AGENDA
Cascade Charter Township Planning Commission
Monday, July 15, 2019
7:00 pm
Cascade Library Wisner Center
2870 Jacksmith Ave. SE

STAFF REPORT: Case # 19-3534
REPORT DATE: June 21, 2019
PREPARED FOR: Cascade Charter Township Planning Commission
MEETING DATE: July 15, 2019
PREPARED BY: Steve Peterson, Planning Director

REQUESTED ACTION: Type II Special Use Permit for Day Care center.

UTILITY PLAN
 THE LEARNING EXPERIENCE - 5333 CASCADE ROAD SE
 FOR CASADENA LLC
 1820 FERRELL STREET
 GRAND HAVEN, MICHIGAN 49417
 IN: PART OF THE NE 1/4 OF SECTION 16, T14N, R10W,
 CASCADE TOWNSHIP, KENT COUNTY, MICHIGAN.

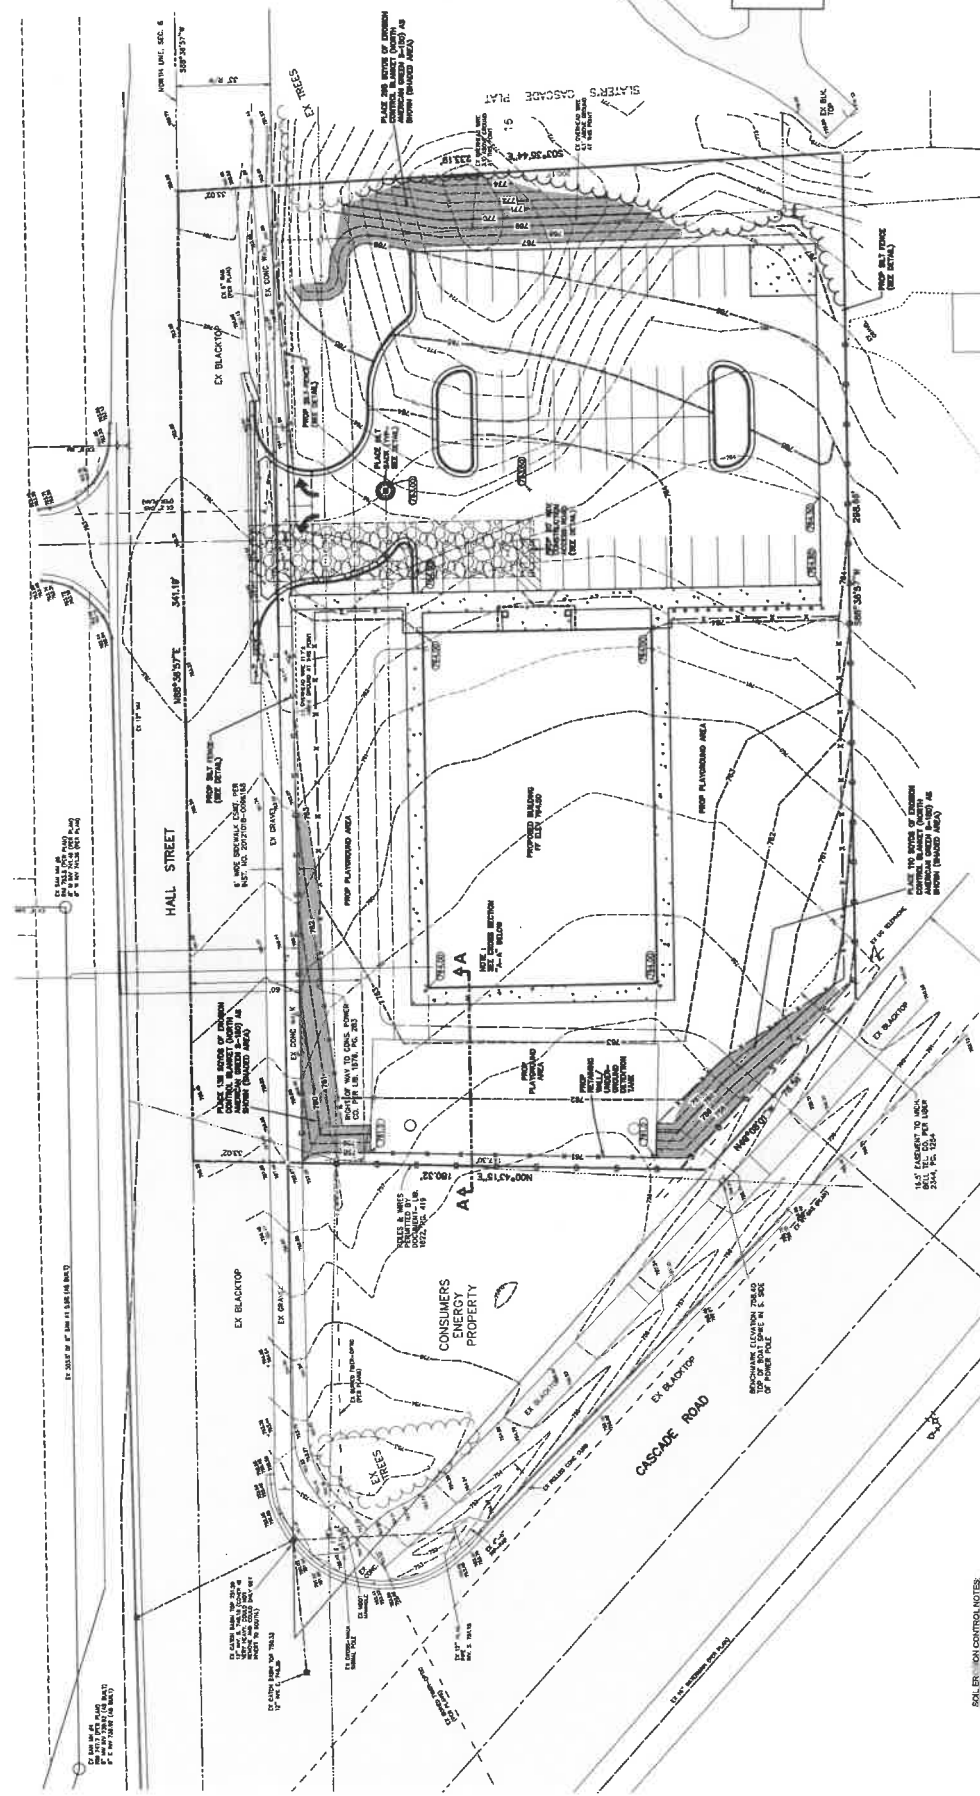
5. The Township fire dept has reviewed and approved the plan.
6. The Township engineer has not approved the plan as of the time this report was written. Both the engineer and I are concerned about putting the playground area above the underground detention system. This seems like a potential conflict for maintenance of the underground system.

- a. Approval from the township engineer.
- b. Relocated the underground detention to the parking lot area instead of the playground.
- c. Revised all plans so they are consistent with the updated site plans.
- d. Updated landscape plan that includes the landscape around the playground fence.
- e. Updated lighting plan to include the wall pack lighting.
